UNITED STATES PATENT AND TRADEMARK OFFICE

APPLICATION NO.	FILING DATE	FIRST NAMED INVENTOR	ATTORNEY DOCKET NO.	CONFIRMATION NO.
10/688,136	10/17/2003	John David Mann	27425-0001	2015

Office Action Summary	Application No. 10/688,136	Applicant(s) MANN, JOHN	
	Examiner Eugene Lhymn	Art Unit 3781

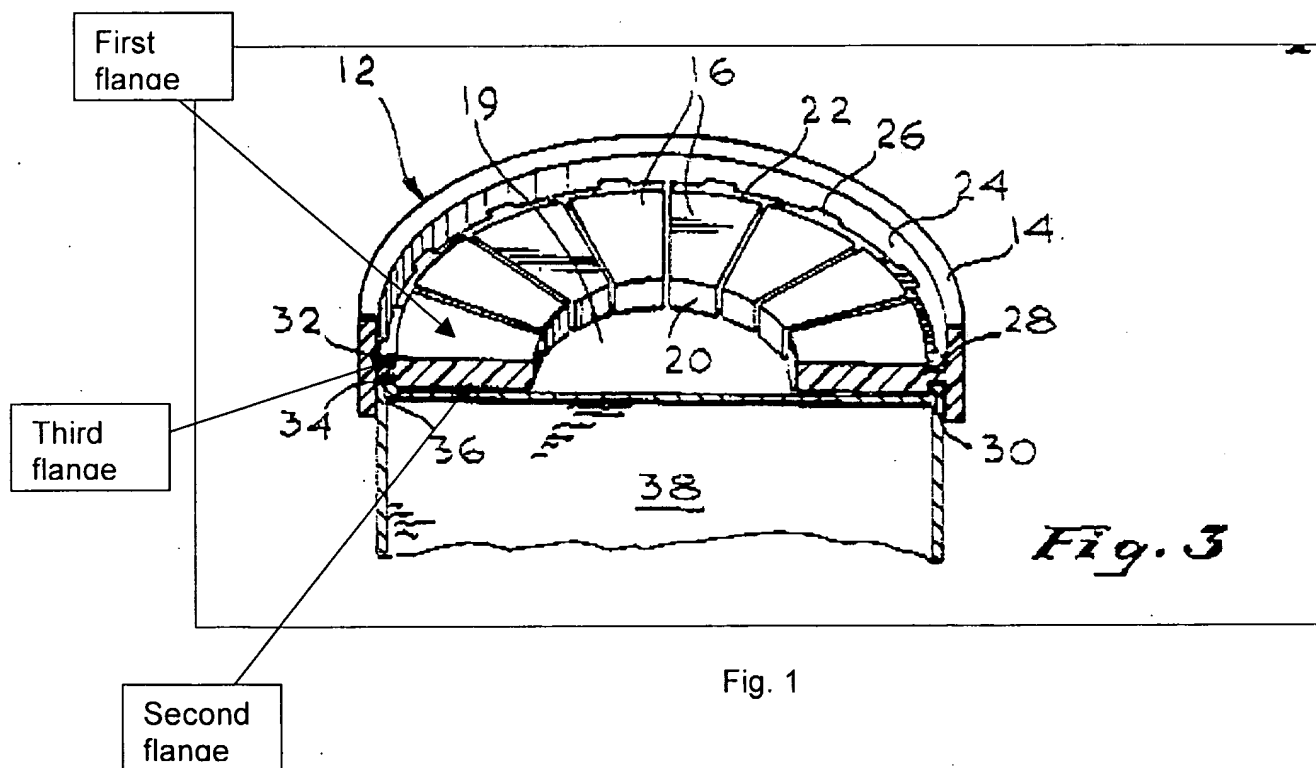
7. Applicant's arguments filed 8/23/06 have been fully considered but they are not persuasive. With respect to claim 1, the upper and lower flanges DO NOT circumscribe the third flange. The upper and lower portions of 16 are radially inward from the third flange which extends perpendicularly beyond therefrom. See Fig. 1 below.
